4.I. 3226 Dogwood Drive Site Plan Review

Anequa Garmon is requesting site plan review to construct a new single-family dwelling at 3226 Dogwood Drive, Parcel Identification Number 14-0094-0001-015-5. The property is zoned V, Village and is subject to the zoning regulations of the City of Hapeville.

DEPARTMENT OF PLANNING AND ZONING
PLANNER'S REPORT

DATE: July 13, 2026
TO: Adrienne Senter
FROM: Lynn Patterson
RE: **Site Plan Review – 3226 Dogwood**

A101
Page 19 of 47

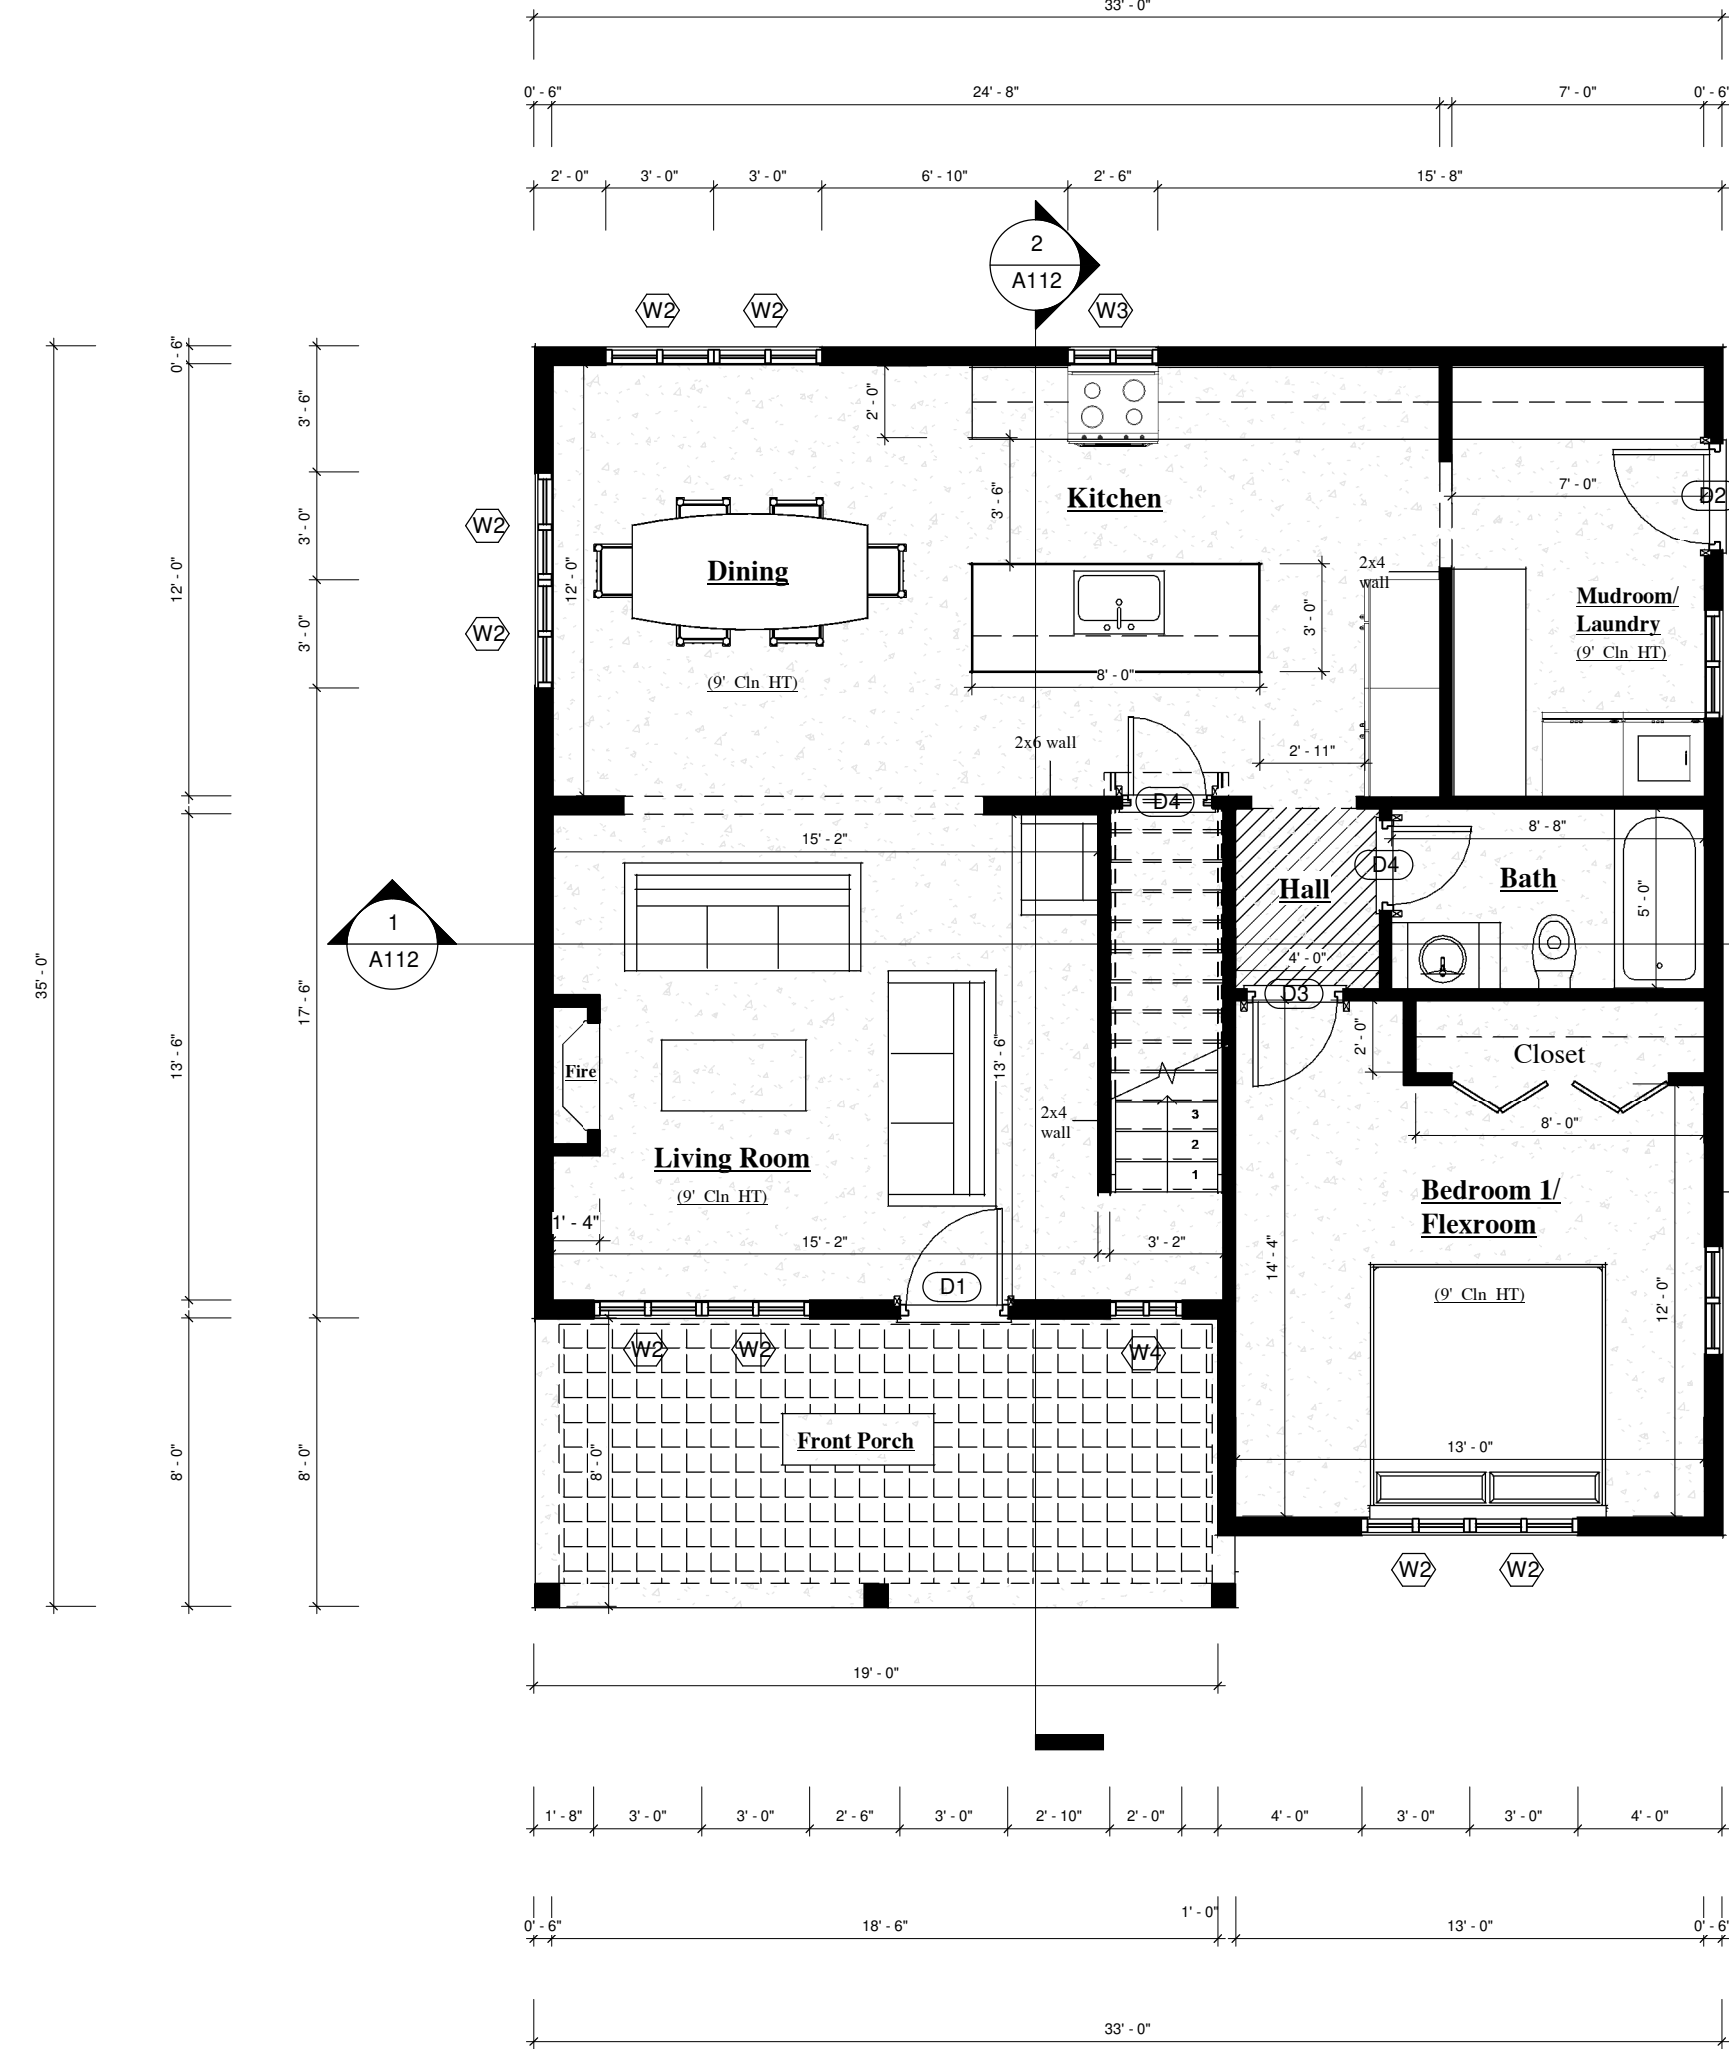
- The application states the proposed dwelling is "not to exceed 1500 SF", the Design Review Application states the construction will be 1,100 SF however, the plans submitted show a 1,950 SF single family dwelling with a 153 SF front porch.
